Re: Bid Number: 05-21FEB08 - Addendum #2

1 STORAGE TANK IMPROVEMENT PLAN
SCALE: 1"=20'-0"

BOONE CO. PUBLIC WORKS COLUMBIA, MISSOURI		
MALICOAT - WINSLOW ENGINEERS P.C. 5649 N. CLEARVIEW ROAD COLUMBIA, MISSOURI 65202 TEL 573-875-1300 FAX 573-875-1305 email: info@mwengrs.com FREDDIE MALICOAT, P.E.		
SHEET: M1 OF M1	DATE: 01-31-08 REVISIONS: 02-13-08	CONTRACTOR SHALL CHECK & VERIFY ALL DIMENSIONS & CONDITIONS AT JOB SITE. 02-13-08

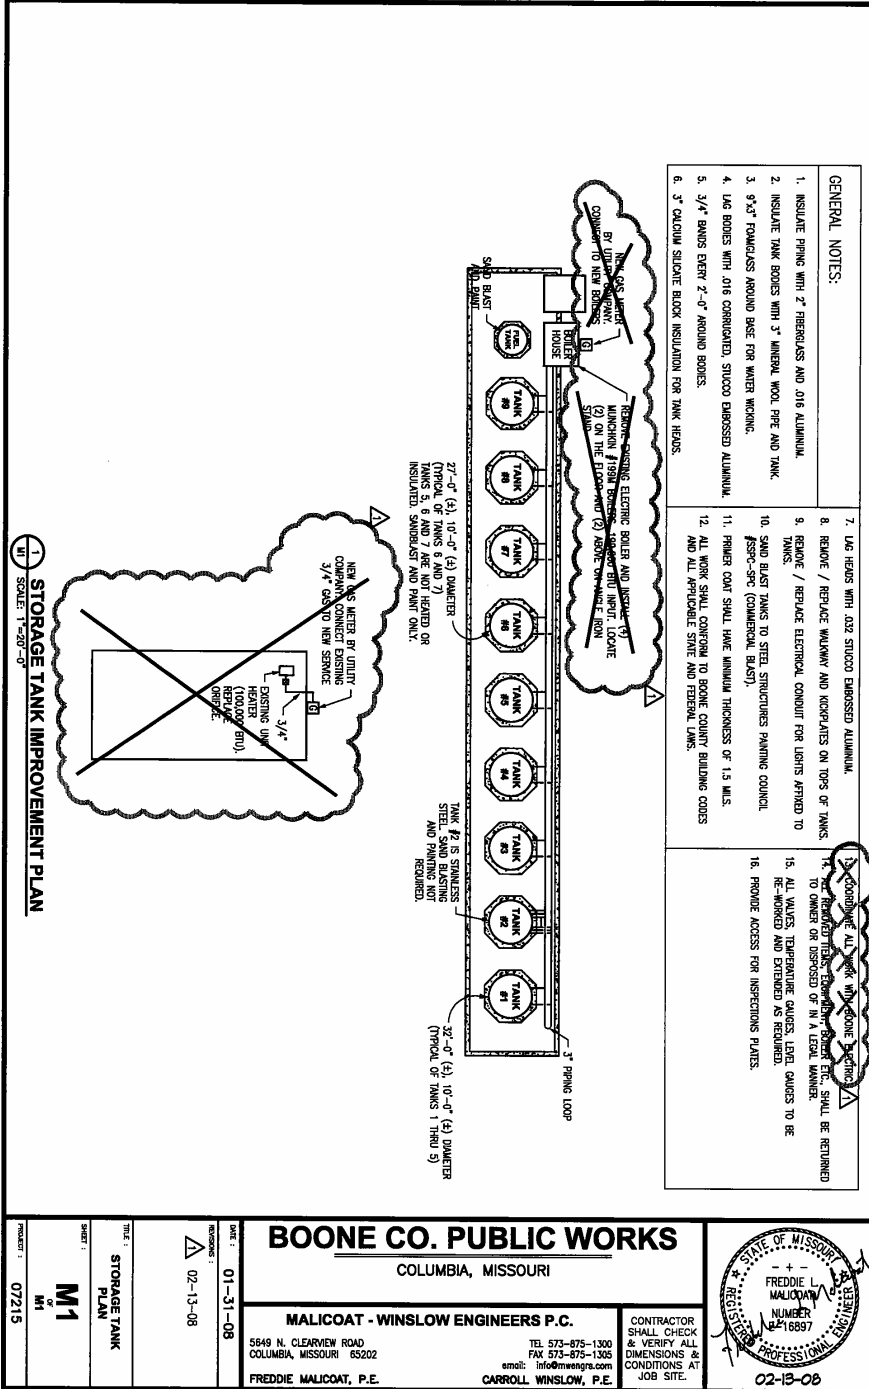
- Item 1. Omit general note #13 on Plan Sheet M1.
- Item 2. Omit all boilers and related gas piping to boilers and unit heater.
- Item 3. Add: tanks #8, and #9, to be sandblasted, primed, and painted.
- Item 4. Add: tanks #1, #3, #4, and #5, to be sandblasted, and primed.
- Item 5. See revised bid form.
- Item 6. Use a urethane top coat, compatible with primer, for painted tanks.
- Item 7. Prime and paint cat walks and rails with same paint as tanks.
